**TOWN OF LODI  
PLAN COMMISSION MEETING MINUTES  
JULY 11, 2017**

**3. Parcel 11022-247: Preliminary Certified Survey Map to create 4 lots. Located in Section 8 between Rapp & Summerville Park Roads, north of Okee Conservation Park, owned by Smith Revocable Trust, c/o Larry Smith: **SEE ATTACHMENTS "C" & "D" AT END OF MINUTES****

**Date: July 6, 2017**  
**From: Dan Schrum, Ayres Associates**  
**Re: Smith Certified Survey Map (CSM)**

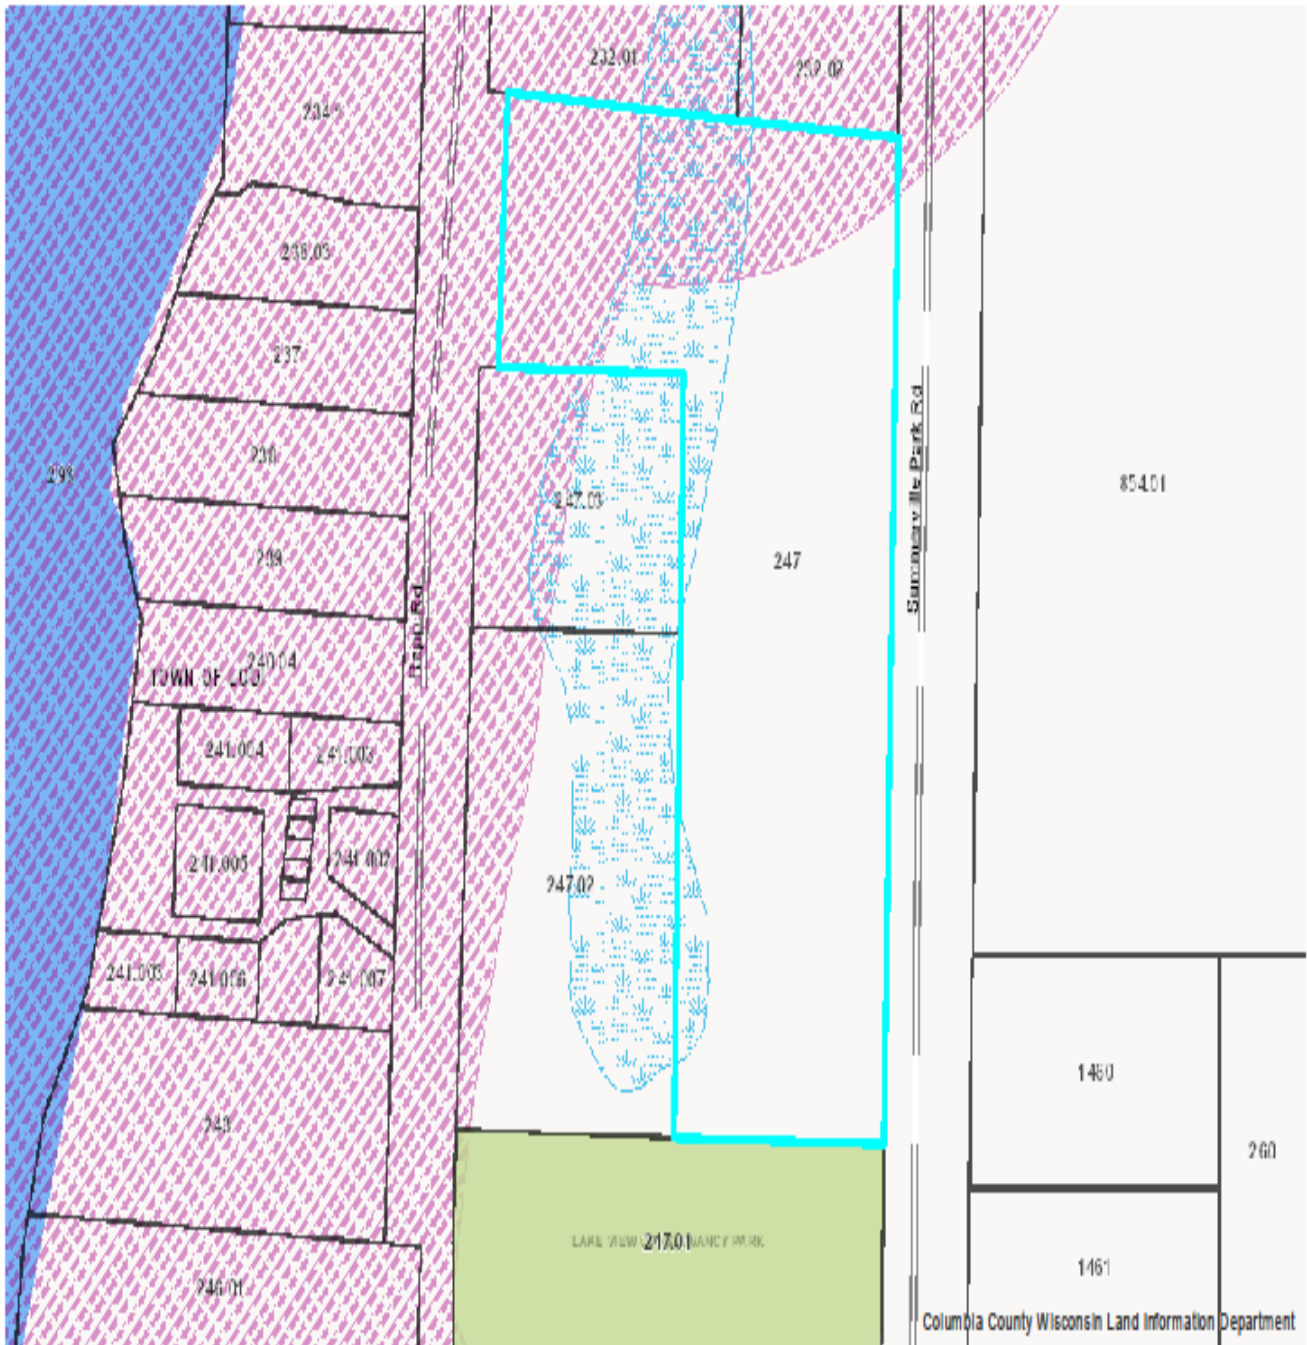
1. Add existing zoning on and adjacent to the proposed land division per Town Ordinance (10.05(c)(2)(I). Lake View Conservancy Park borders this parcel to the south.
2. The CSM is missing the signature page as defined in Town Ordinance (10.05(c)(3).
3. Verify the setback distance from Rapp Road and permanent easement. The 30' setback distance as specified in the CSM does not appear to match that of the Columbia County Interactive Mapping Application (see attachment). Columbia County requires a 63' setback from the centerline of a Town, Village or City Road per Table 16-110-030(2). The CSM shows a 55' setback.

4. The proposed individual Lots meet the minimum 20,000 square foot size within an Urban Service Area per Town Ordinance 10.07(c)(3) for a new subdivision. While this may not necessarily apply, it is pointed out that the standard is met. Additionally, the minimum Lot size per Columbia County Zoning Table 16-110-030(I) of 12,000 square feet (R-1) is also met.

5. Driveway access to the Lots should be discussed. Lot 4 has frontage on Rapp Road and Summerville Park Road. The location of individual driveways must adhere to Town Ordinance Section 5.13 – Driveway Siting.

6. Land Suitability – the land division must adhere to Town Ordinance 10.03(e). An Environmental Assessment may be warranted as stated in Town Ordinance 10.04(J), but could be waived by the Plan Commission for minor subdivisions of less than five acres total area per Town Ordinance 10.04(J)(i).
